HYUNDAI NEW THINKING. NEW POSSIBILITIES.	GROUP	NUMBER
	CAMPAIGN	13-01-032
	DATE	MODEL
	JULY 2013	SANTA FE (NC)
SUBJECT BLOWER PWM MODULE REPLACEMENT (SERVICE CAMPAIGN TP9)

Description: This bulletin provides the procedure to replace the blower PWM module for Santa Fe (NC) vehicles equipped with the Dual Automatic Temperature Control A/C system.

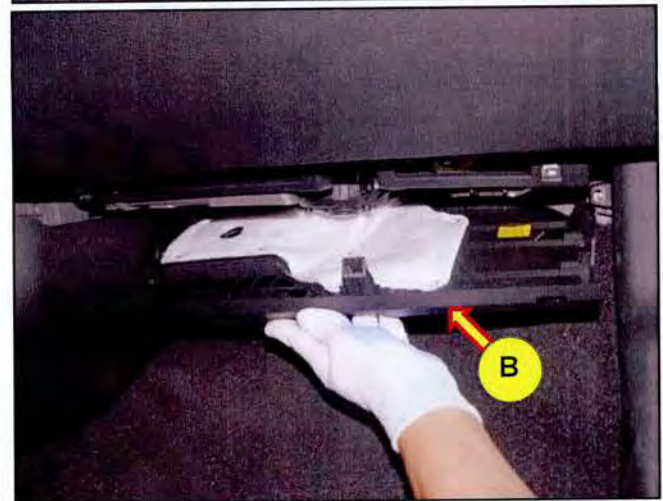
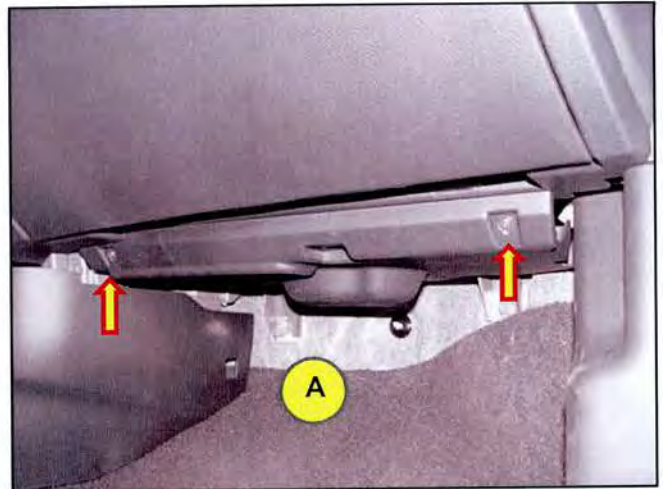
Part Name	Part Number		New Part Identification
	Previous	New	
BLOWER PWM MODULE			New part has a yellow colored label.
	97235-4RAA0	97235-4RAA0QQH

4. Install the new blower PWM module (yellow colored label part as shown in page 1) in the reverse order of removal.
5. Operate the A/C blower to verify proper system operation.
